### 7. KRUSES STREAM LANDSCAPING PROPOSAL

1. The purpose of this report is for the Shirley/Papanui Community Board to approve the concept plan for the Kruses Stream Landscaping Proposal at 5 Vagues Road, and to consider a name for the neighbourhood park to recommend for Council adoption.

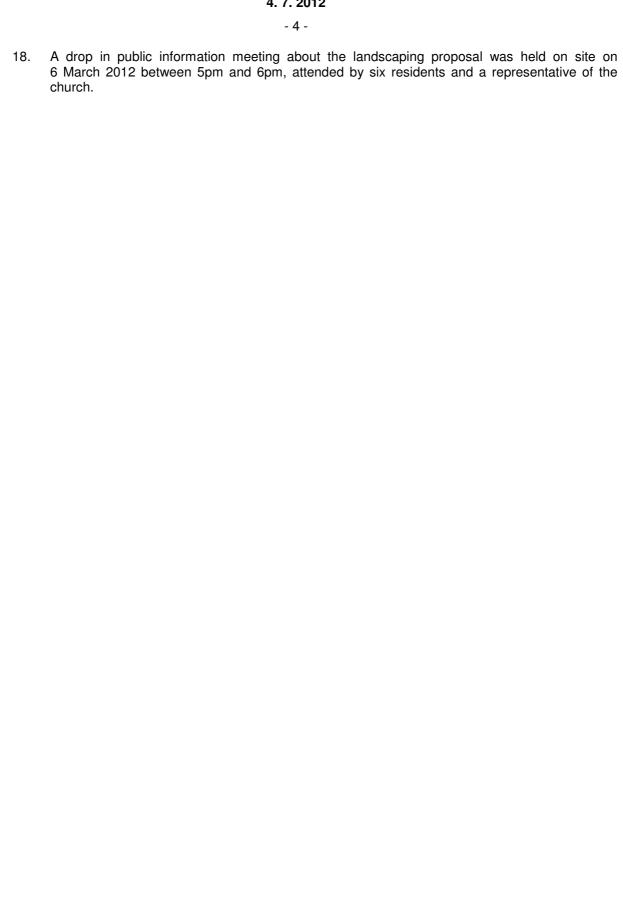
- 24. Changes to the proposed park were made in response to concerns raised about the drain during consultation on the landscaping. This resulted in the need to consider flooding issues, including increasing the capacity of the stream through this reach.

- 25. Changes to the proposal which have resulted in the final Plan for Board Approval are as follows:
  - (a) The stream bed has been widened.
  - (b) The top of the bank has been changed to anticipate the possibility of flooding to higher levels at the site.

- (c) The rock steps will be modified to allow for use during high water flows.
  - (d) The sloping gravel beach has been removed and the north bank modified slightly and planted.
